**Re: Consent Decree, Civil Action Nos. JFM-97-558, JFM-97-559
Coke Oven Area Interim Measures Work Plan
Response to EPA letter dated May 26, 2010**

**COKE OVEN AREA INTERIM MEASURES WORK PLAN
SUPPLEMENTAL INFORMATION
JUNE 2010**

Figure 5-4 (revised)

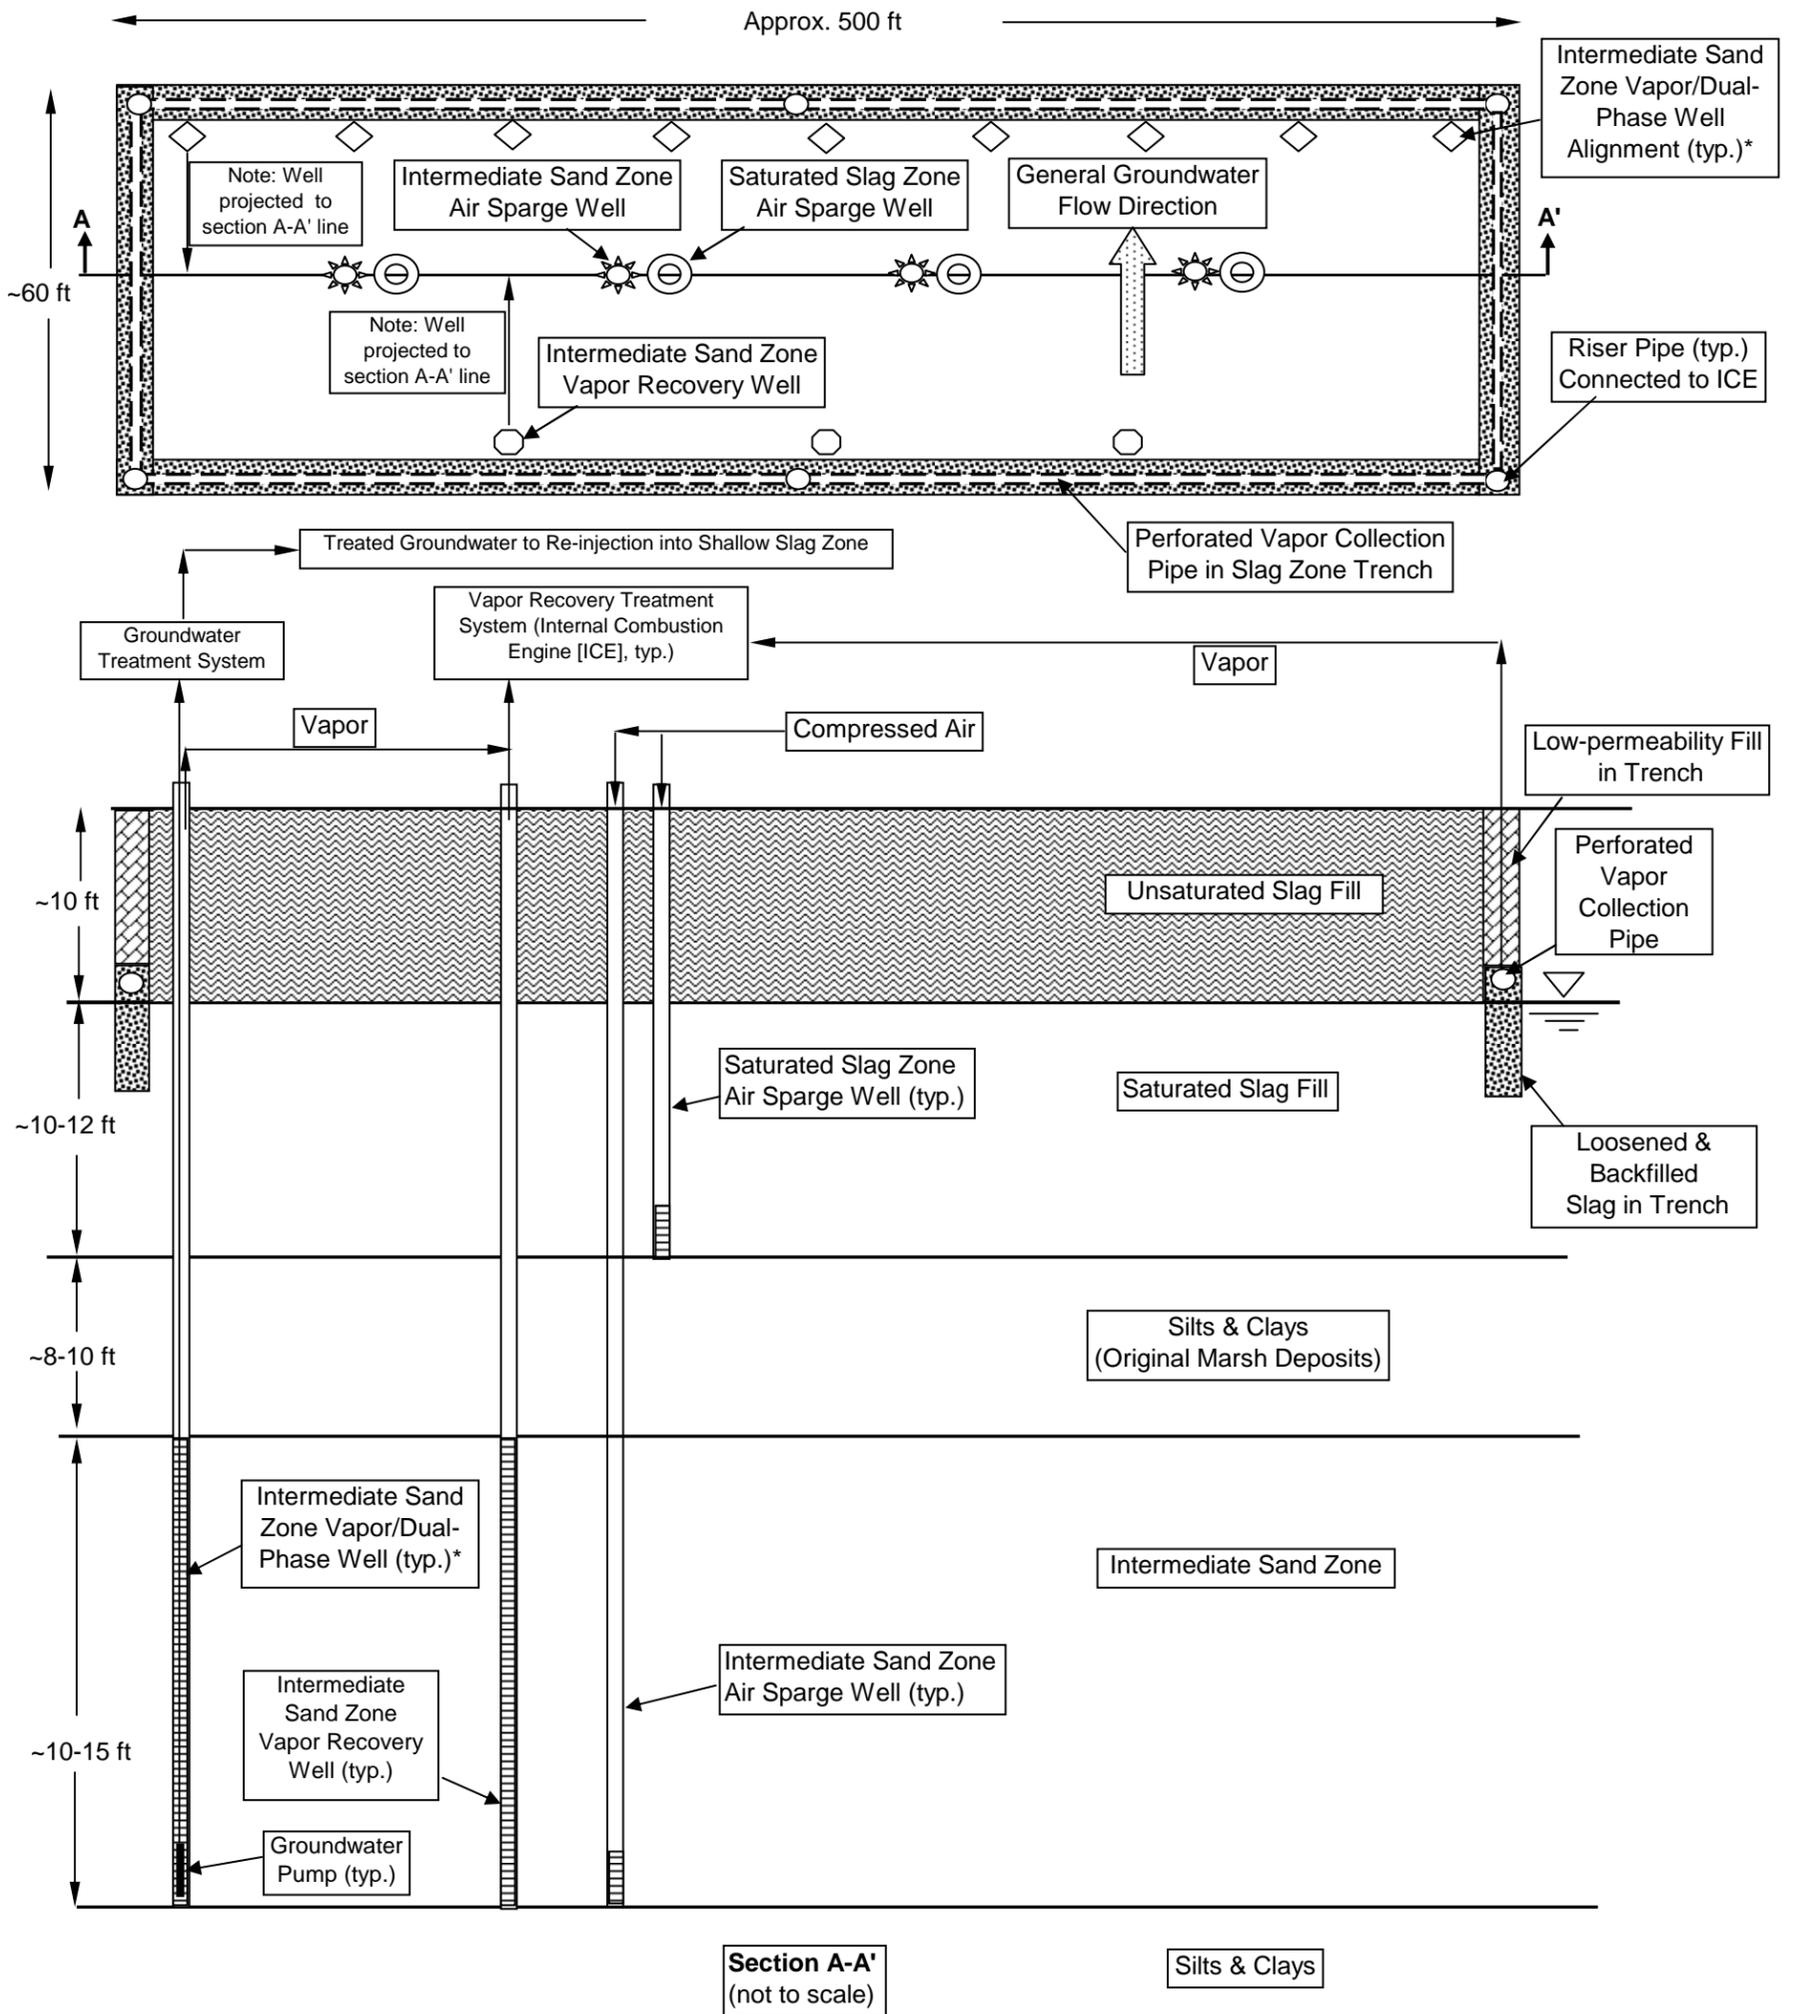
1. Modification of vapor recovery wells into dual-phase groundwater and vapor extraction wells at the former Coal Storage Area (Cell 2);
2. Addition of ground water extraction wells near the Turning Basin (Cell 5);
3. Addition of dual-phase extraction wells to former Benzol Processing LNAPL Area (Cell 6).

As a result of the June 3rd technical telephone call and as agreed to by U.S. EPA, MDE and Severstal, design modifications are outlined in this document to install a dual-phase ground water extraction system in the former Coal Storage Area (Cell 2). While U.S. EPA's May 26, 2010 letter also directed that Severstal propose an accelerated schedule to implement AS/SVE systems in Cells 2 and 3; as a result of the June 3, 2010 technical discussion U.S. EPA, MDE and Severstal mutually agreed to evaluate the performance of the Cell 1 AS/SVE system following submittal of three months of operating data. Evaluation of the three months of operating data from Cell 1 will be used to establish the basis to move forward with the AS/SVE in Cells 2 and 3. Upon U.S. EPA approval of the AS/SVE work in Cell 1, Severstal will support the implementation of AS/SVE in Cells 2 and 3 within approximately six months subject to the appropriate construction season constraints. Assuming U.S. EPA and the MDE approve and appropriately permit the AS/SVE operating performance for Cell 1 by the end of December 2010, Severstal will then be in a position to complete installation and operation of the AS/SVE in Cells 2 and 3 within six months of EPA approval, consistent with the cooperative goal of operation of all cells by July of 2011.

The Cell 2 system will include: 1) groundwater extraction and vapor recovery from selected wells installed into the semi-confined intermediate sand unit below the slag groundwater zone, 2) groundwater treatment, 3) groundwater re-injection, and 4) AS/SVE in both the slag groundwater zone and the semi-confined intermediate sand unit below the slag zone, as shown on **Figure 5-1 (revised)** and **Figure 5-4 (revised)**. Groundwater will be extracted from selected wells in the semi-confined intermediate zone as necessary to capture groundwater along the recovery well alignment (**Figure 5-4 [revised]**).

Figure 5-6 (revised)
 Coal Tar Area (Cell 4)
 In-situ Anaerobic Bio-Treatment Area^(a)
 Section A - A'

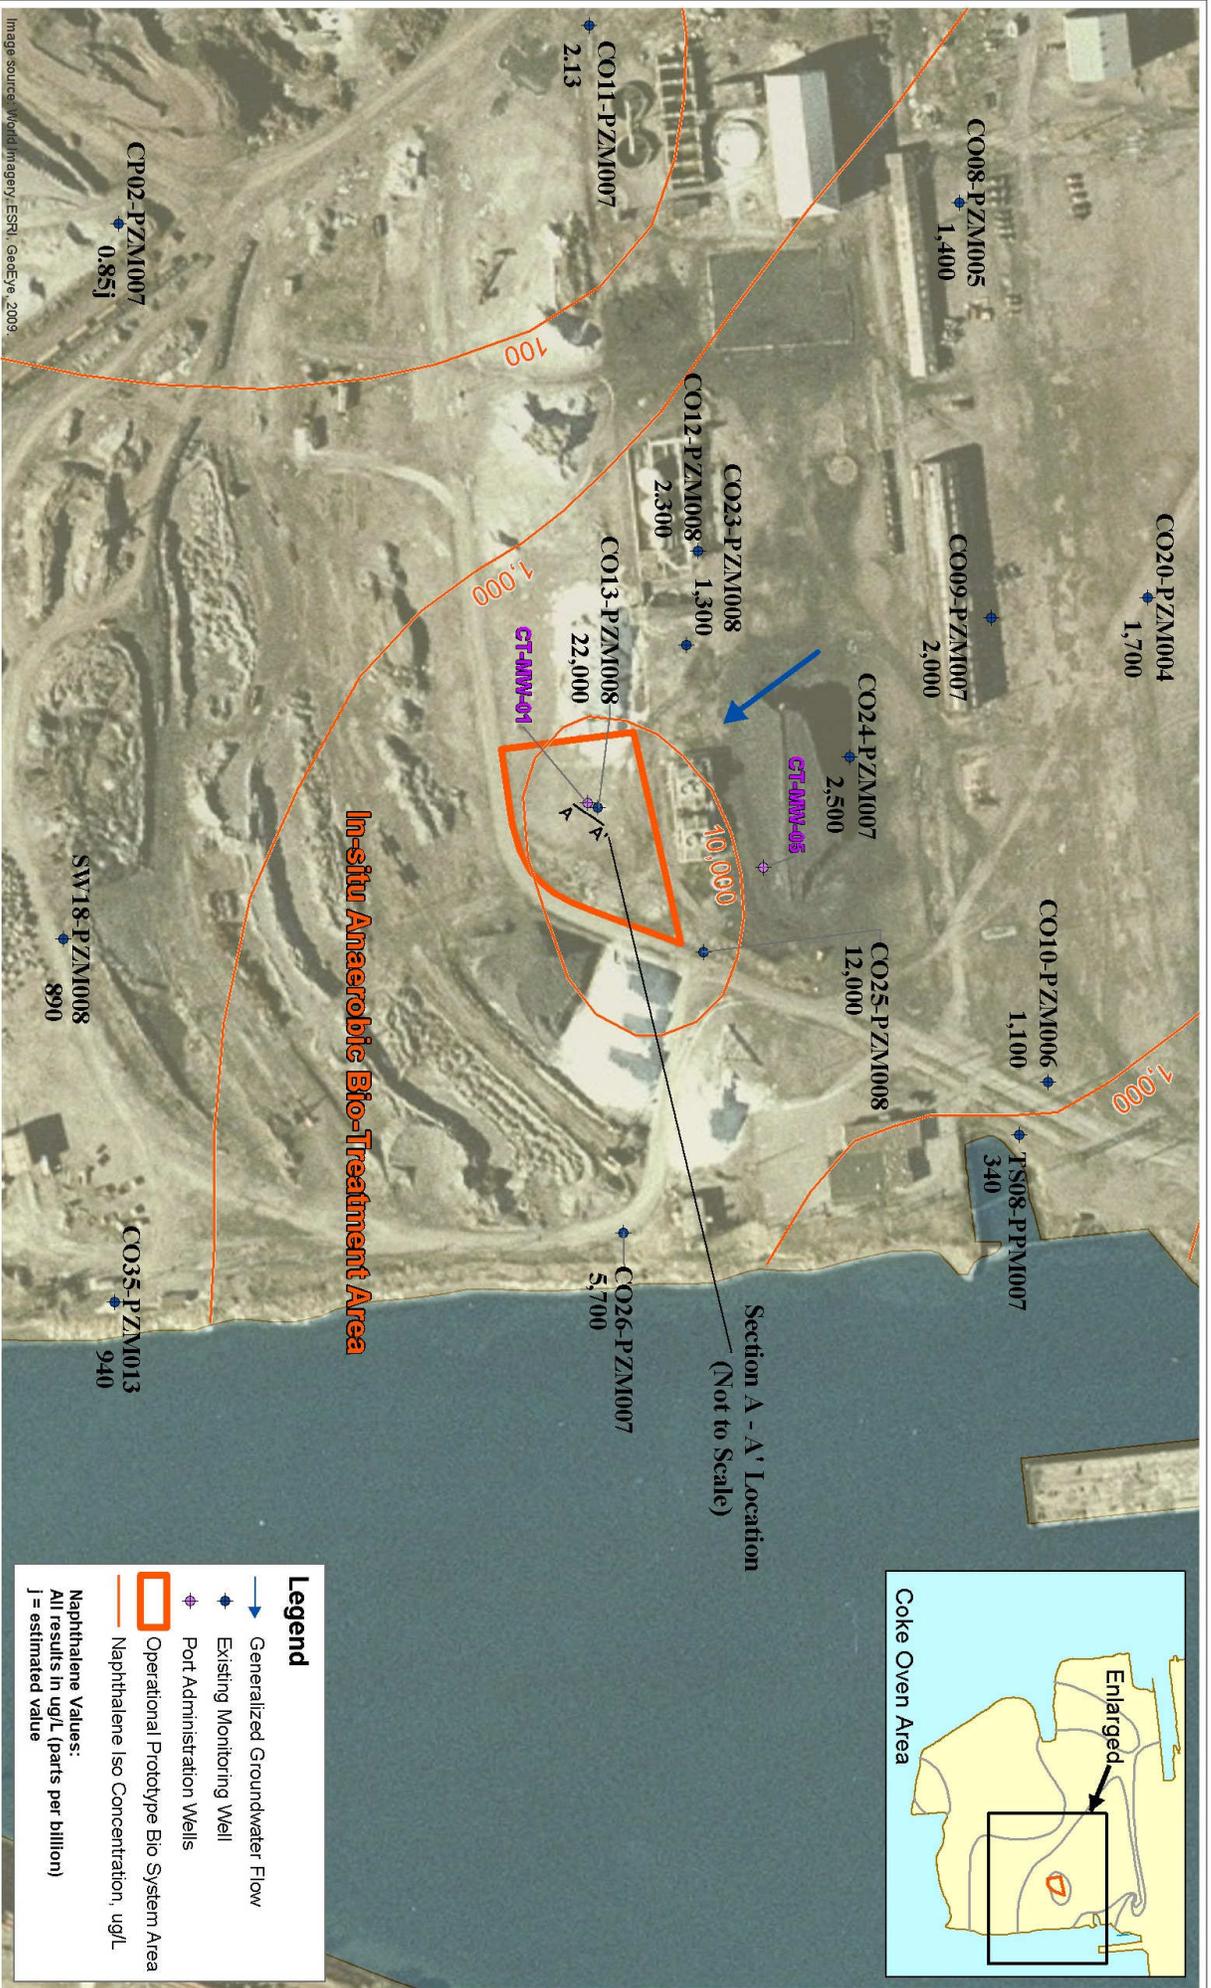
Severstal’s goal is to perform treatability evaluations on groundwater from Well CO26-PZM007 (**Figure 5-6 [revised]**) and develop a preliminary design concept by late October 2010. Consistent with Cell 2; Severstal proposes a late-October 2010 meeting with MDE to discuss results of the treatability testing and MDE’s re-injection requirements in order to begin preparing the necessary permit application documents. Re-injection requirements must be identified at that time in order to prepare appropriate permits and receive MDE approval of the groundwater re-injection process by mid-January 2011. Severstal will then be in a position to complete installation and operation of the Cell 2 system within six months of approval, consistent with the cooperative goal of operation of all cells by July of 2011. The groundwater treatment system design and implementation schedule described herein is based on incorporating treatment units that are commercially available, temporary or mobile, and reasonable in scope as outlined in the March 2 2010 EPA letter.

Revised Figure 5-7
Schematic Diagram of Proposed Enhanced Anaerobic Bio-Treatment Re-Circulation Prototype System
Cell 4 (Former Coal Tar Storage Area)
Severstal Sparrows Point, LLC

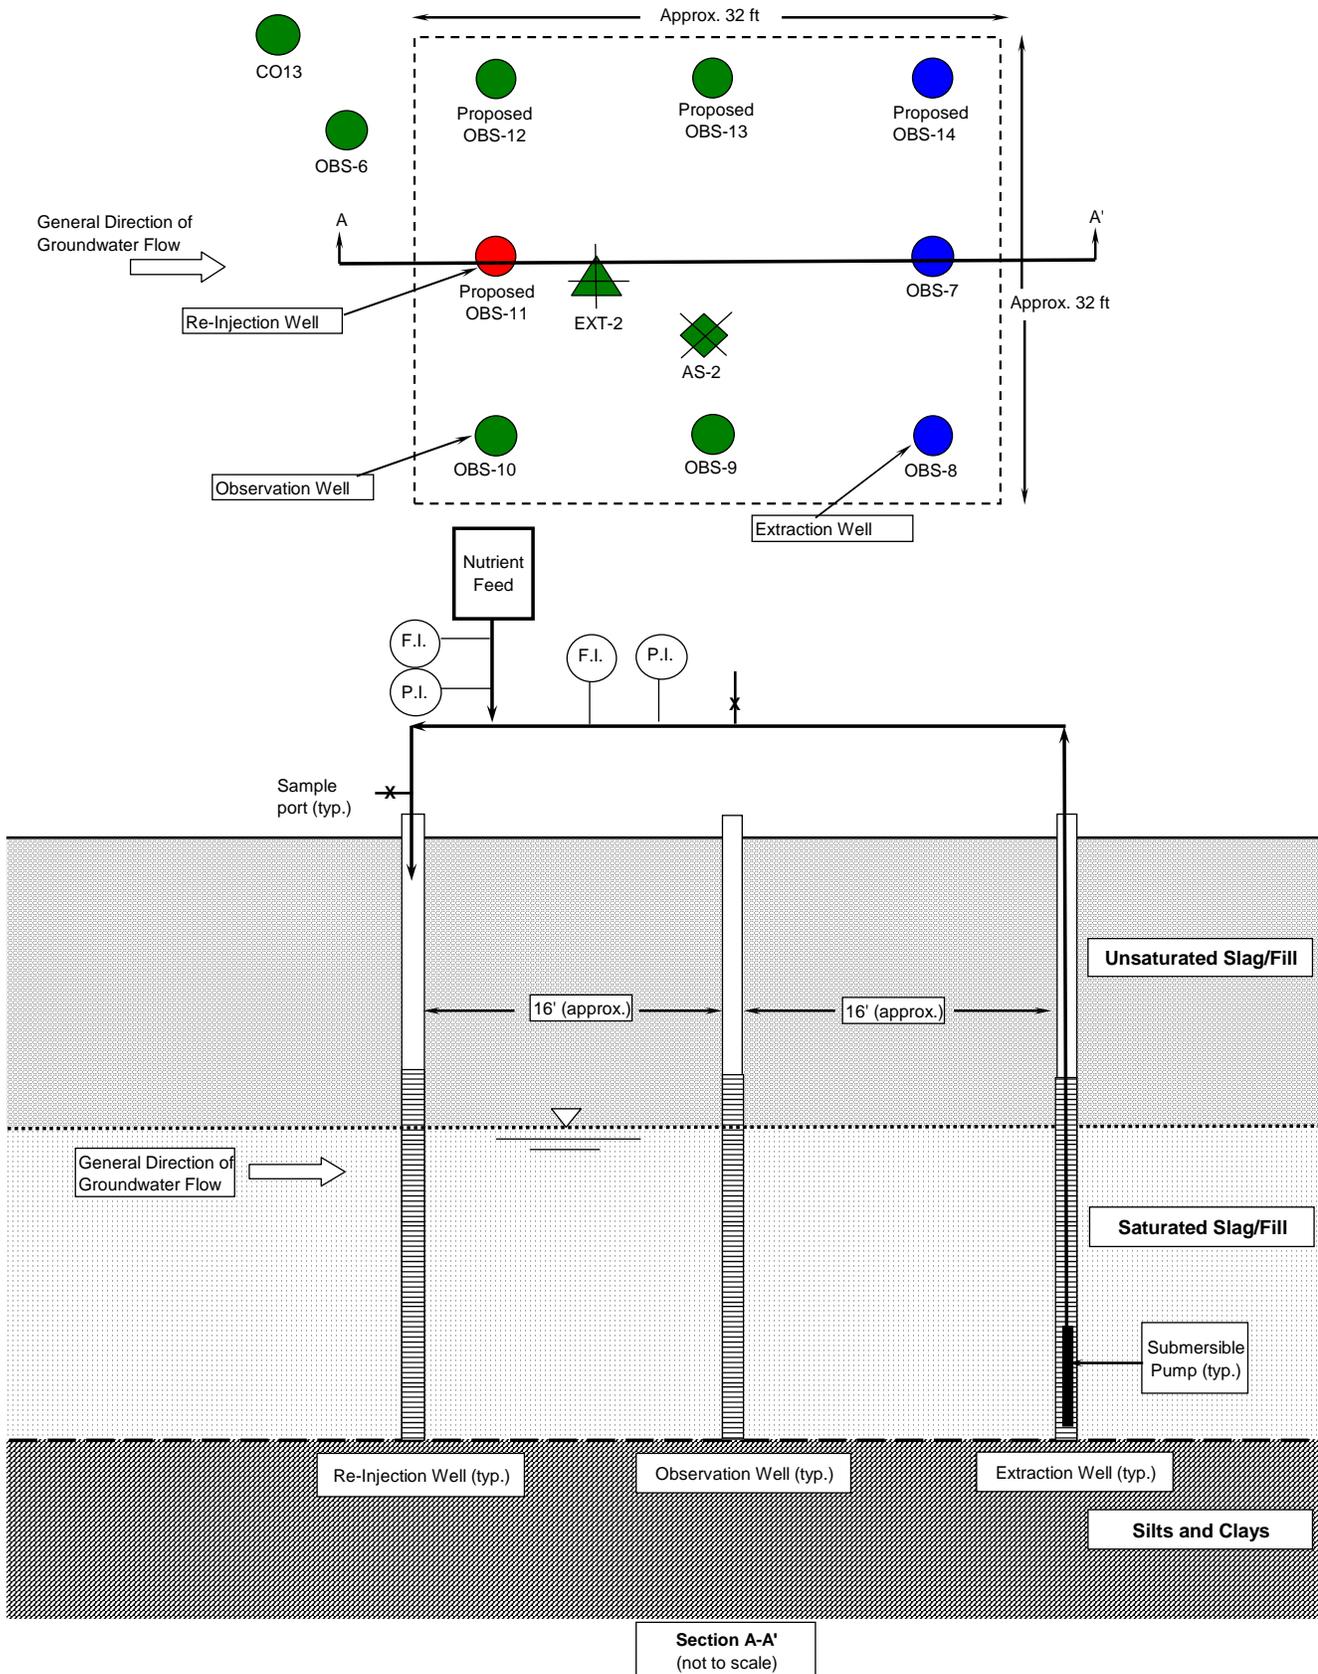
The location and scope of the in-situ anaerobic bio-treatment area is shown in detail on **Figure 5-7 (revised)** and will incorporate existing wells to enhance implementation and evaluation of the concept. Additional wells are planned to be installed as necessary to develop a groundwater recirculation system in which water will be withdrawn from down-gradient wells, amended with nutrients/other additives to enhance microbial activity, and recirculated up-gradient to complete the recirculation system. The nutrient/additive mixture and other system design features (groundwater pumping/recirculation rate, etc.) will be developed based on the initial (i.e., baseline) “Bio-Trap” results.

Severstal proposes to recirculate groundwater within the in-situ anaerobic bio-treatment area (Cell 4) that is amended with only nutrients or other amendments selected to enhance microbial activity. No treatment or permitting requirements to recirculate groundwater in this cell are anticipated for the following reasons:
